City of Richmond
Urban Development Division

Report to Development Permit Panel

To: Development Permit Panel
From: Joe Erceg
Manager, Development Applications
Date: April 2, 2003
File: DP 02-212758
Re: **Application by London Landing Development Corp. for a Development Permit at 6400, 6420 Princess Lane and 6411, 6431 Dyke Road**

1 SITE PLAN
 SCALE: 1/8" = 1'-0"

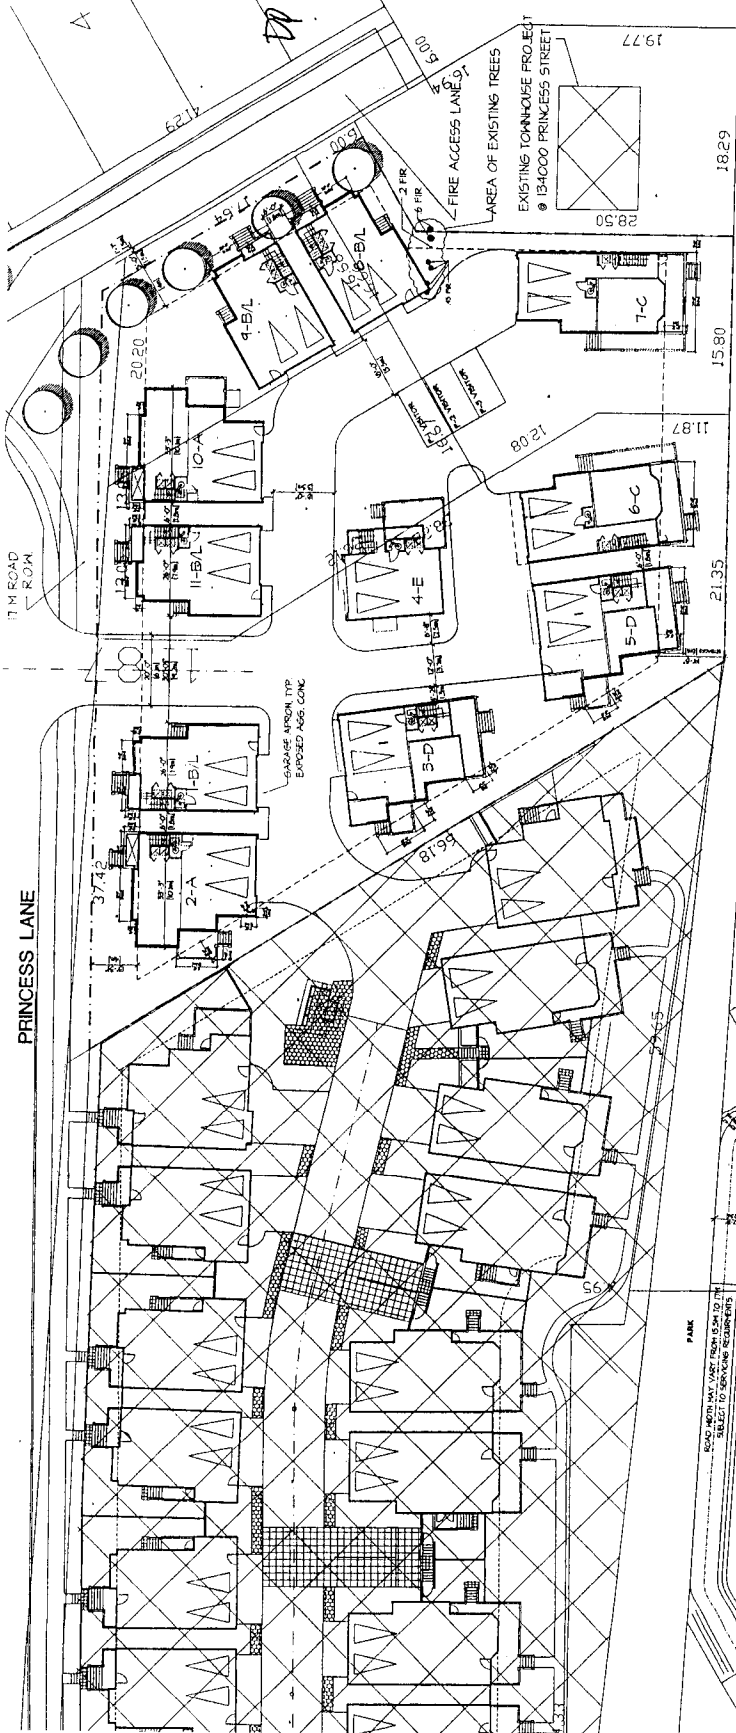
2. The site planning of units in this complex is awkward and inefficient. In particular, the location of the 4-E unit in the centre the complex impacts the liveability of this unit and the privacy of other nearby units. Consider alternative site planning arrangements that mitigate the negative impacts of this central unit. Consider the following options:

2. Provide dimensions for the layout of private roadways. *The applicant has complied, please see the attached drawings.*
3. Visitor parking spaces need to be identified and designated as such. *The applicant has complied, please see the attached drawings.*

- The applicant has rejected these suggestions indicating the higher financial returns can be achieved from detached units and therefore prefers the site plan as previously proposed (i.e. two (2) units in the centre of the site with no substantive change to the proposed private roadway configuration.*

#4a.

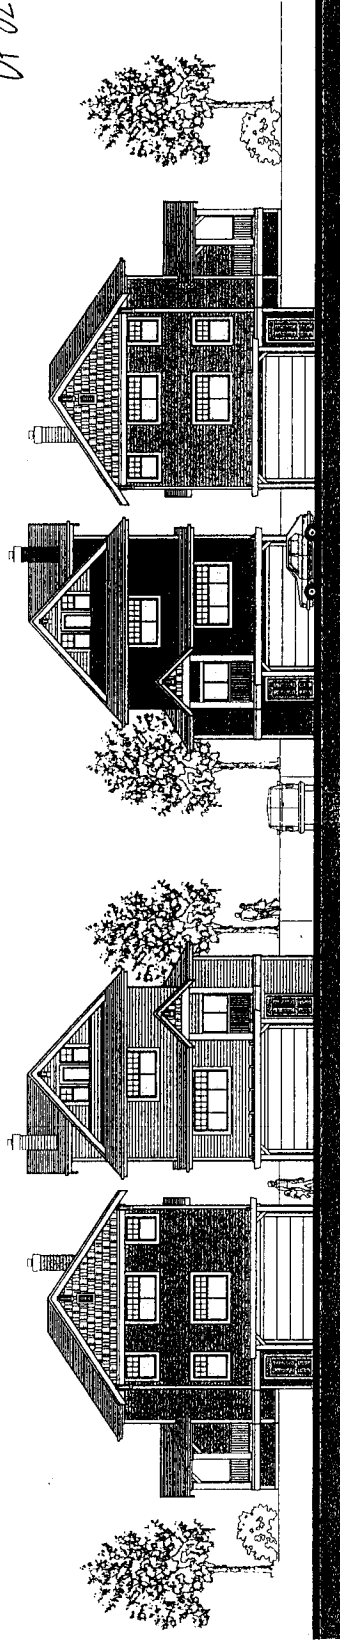
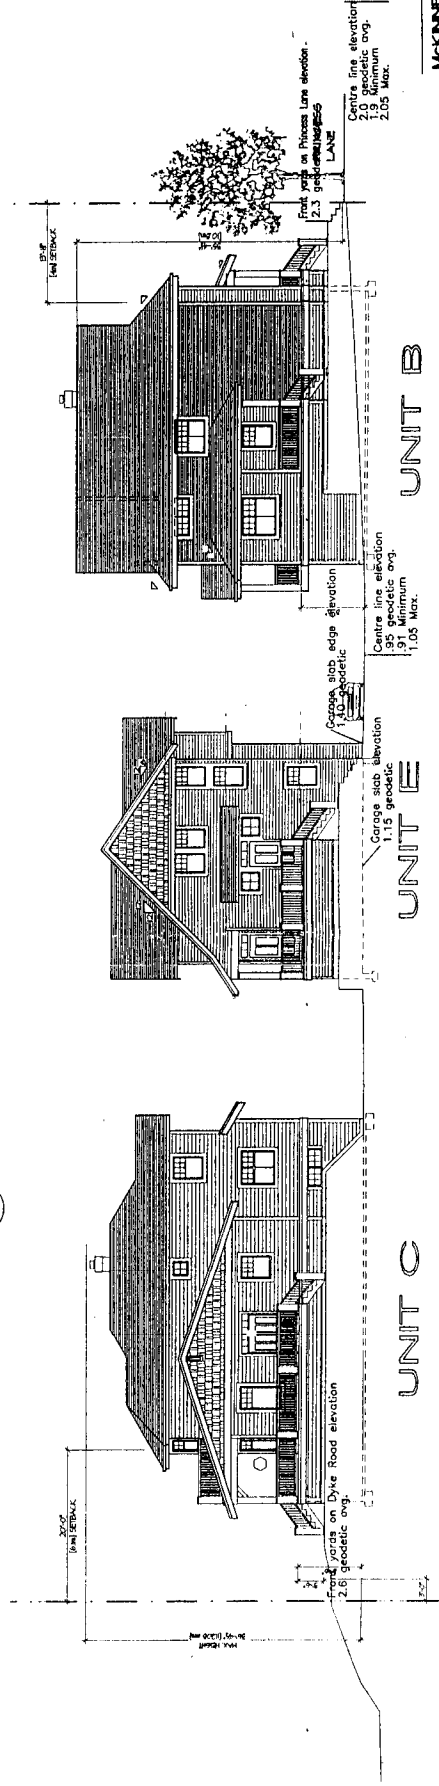
4. Provide a series of continuous sectional elevations across the site to illustrate the relationship of built form to circulation, open space and proposed grading. *The applicant has complied and the sectional elevation drawings are attached.*

#AC

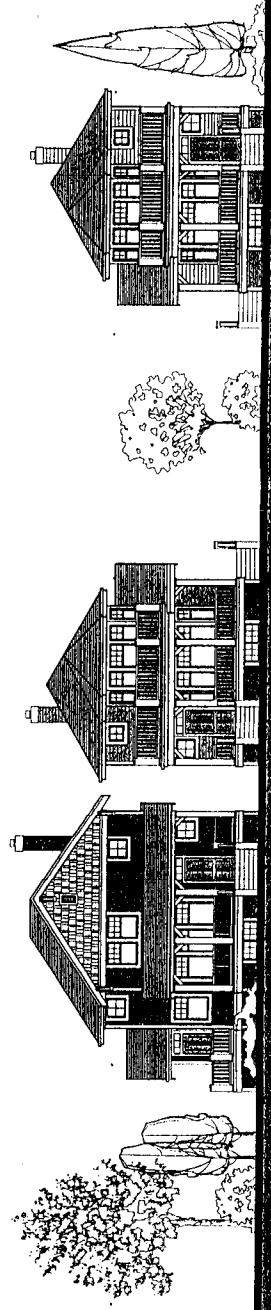
5. Provide a series of continuous architectural elevations around the entire perimeter of the site. *The applicant has complied and the sectional elevation drawings are attached.*
